8.1. Langhorne Creek Discovery Trail - Community Engagement Feedback and Next Steps

Responsible Officer: Stacey Bateson (General Manager Community)

Report Author: Sarah Longden (Senior Town Planner)

For the Langhorne Creek Discovery Trail (LHCDT) project, this report seeks for Council to receive the submissions from the community engagement on the original concept plans, to approve the amended concept plans for a grant funding submission and endorse the initiation of the process to open a section of road over a portion of a parcel of land for the facilitation of the trail.

FROST MOTORS
LANGHORNIE CREEK
SK02 1:100 03-24

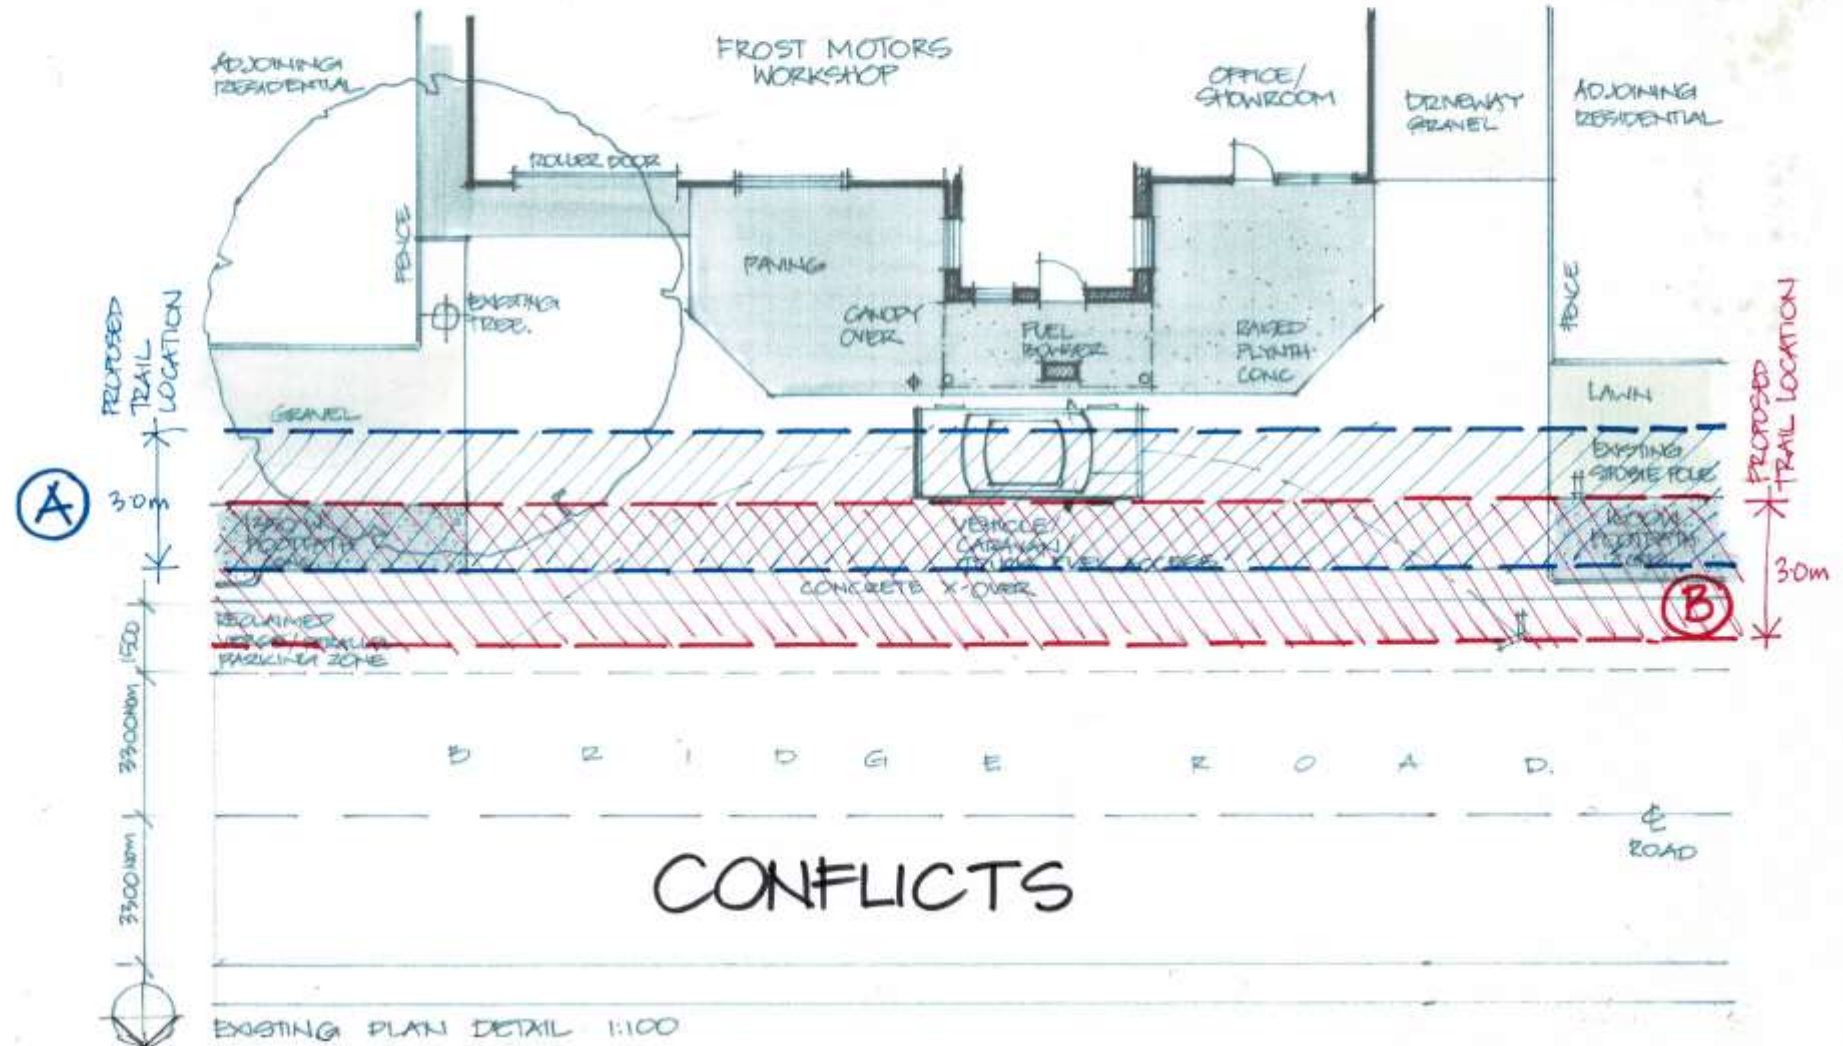
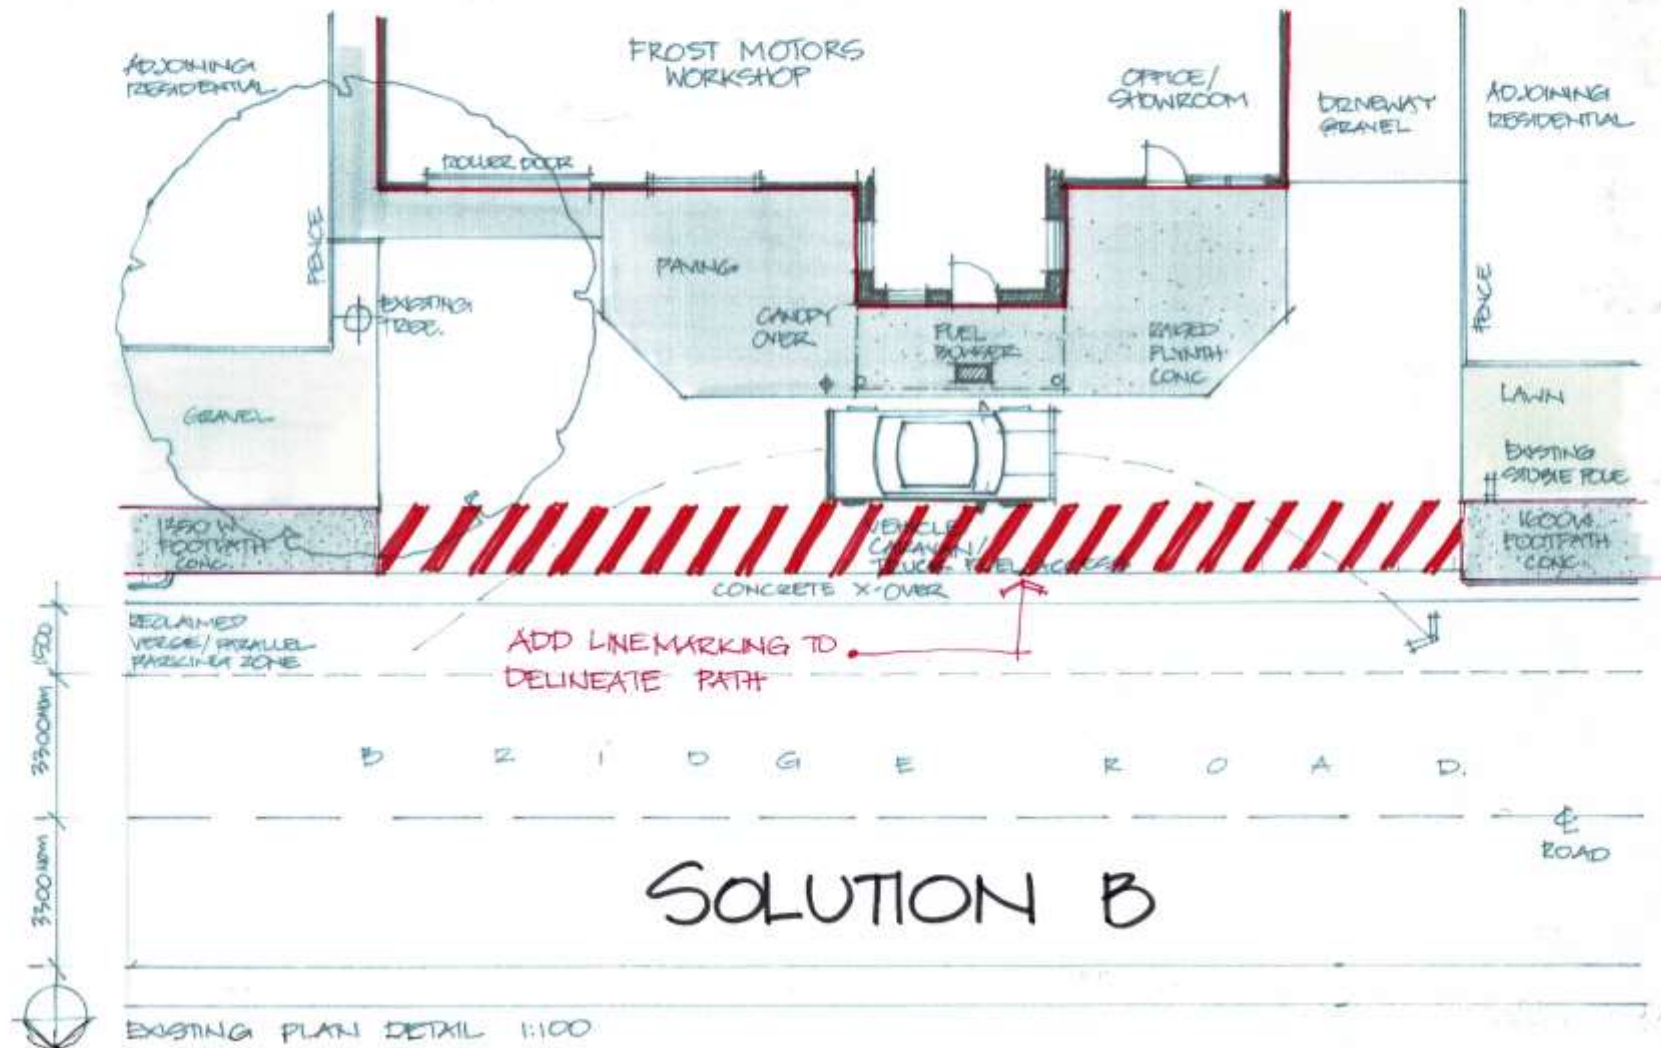
CONFLICT DESCRIPTION:

- (A) PATH WITHIN FOOTPATH
 - CONFLICTS WITH STOBIE POLES/ VERGE TREES/ X-OVER LEVELS/ FUEL BUNKER ACCESS
- (B) PATH WITHIN ROAD
 - REDUCTION OF ON STREET PARKING/ AG. EQUIPMENT CLEARANCES.

DISCOVERY TRAIL SITE IMPACTS

SOLUTION A NORTH SIDE TRAIL

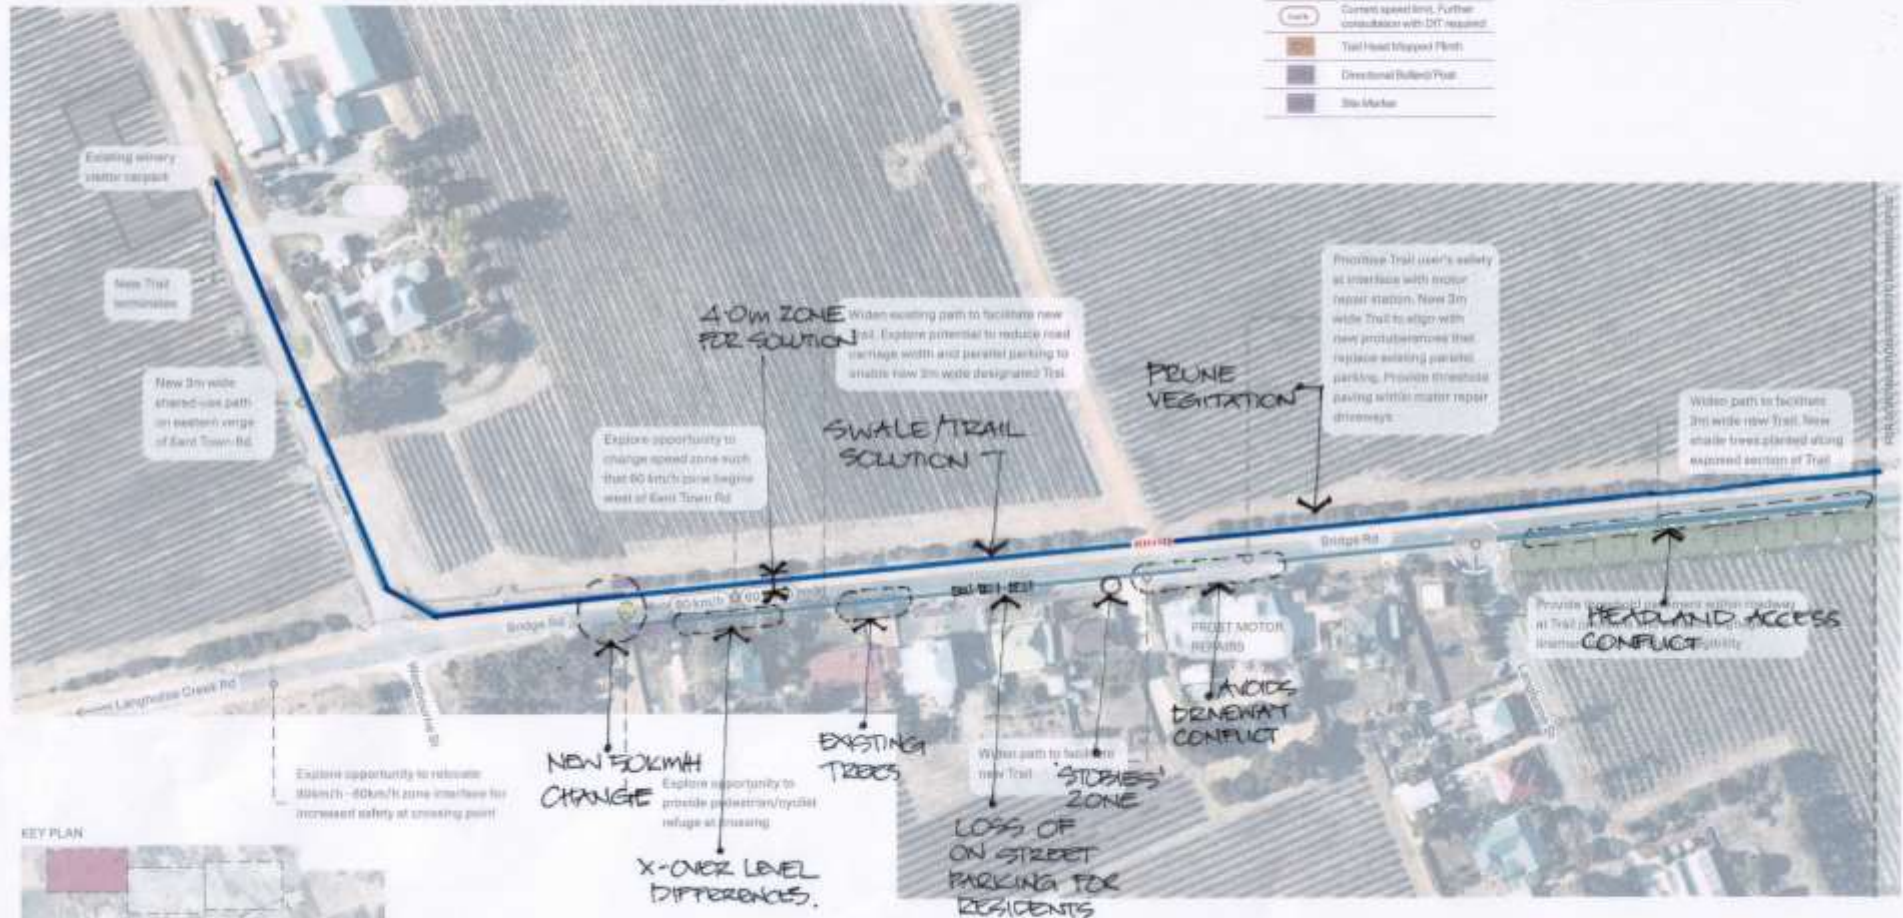
Concept Plan Drawing CP-01 1. Path infrastructure shouldn't be installed on Kent Town Road as it is already bitumen and not a busy road. 2. There is now infrastructure and trees in place on the Eastern side of Kent Town Road. 3. The trail crossing Bridge Road at the front of Bremerton should be at the corner of Bridge Rd/Westbourne St across to Bridge Rd/Kent Town Rd 4. Opportunity to send trail down Westbourne street, then left across the northern boundary of the Oval grounds, straight onto Victoria Street, Left down Langhorne Street and then right onto Bridge Rd. 5. There is sufficient road width required for truck turnout on the driveway opposite Frosts motor repairs. This is an exit point for trucks from Bremerton back onto Bridge Road. CP-03 and CP-04 - Path to stay on southern side of main road from Bleasdale through to Pub. There could be marked areas to cross the Langhorne Creek Road opposite Kimbolton and The Winehouse. This would avoid having to have a path in front of the houses between The Winehouse and Kimbolton. It would also be safer to avoid having people continue to walk on the Southern side without a path. The corner near the Western most point of Frank Potts reserve is so dangerous for people walking between the town and Frank Potts Reserve after hours. They would not cross the road for such a short distance. Other Points Would be great to have trail continue 650m to the intersection of Lake Plains Road so the trail could continue down to Rusticana/Alices B&B/Metala.

Suggested Amendment/Inclusion	Number of mentions	Can a change be achieved to accommodate this?	Notes
3.0 metre width not necessary/excessive	14	Yes	Reduce overall width 2.0 or as close as practicable within applicable guidelines
Relocate to the northern side of Bridge Road	11 Bremerton to Post Office 3 Bremerton to General Store 2	Yes	Amending the proposed route of the trail to commence on the corner of Bridge Road and Kent Town Road and run along the Northern side of Bridge Road to the Post Office, minimises the impact on businesses and residences located along this stretch.
No loss of carparking	9	No	Narrowing of the path will result in as little loss as possible of car parking along the route. Truck and caravan parking adjacent Alfred Langhorne and the General Store will not be impacted.
Flaws with positions of crossings/ pedestrian refuges	6	Yes	Remove all crossing/pedestrian refuge infrastructure and make sure crossing points have appropriate signage and sightlines (DIT approved traffic engineer report to provide recommendations on sightlines)
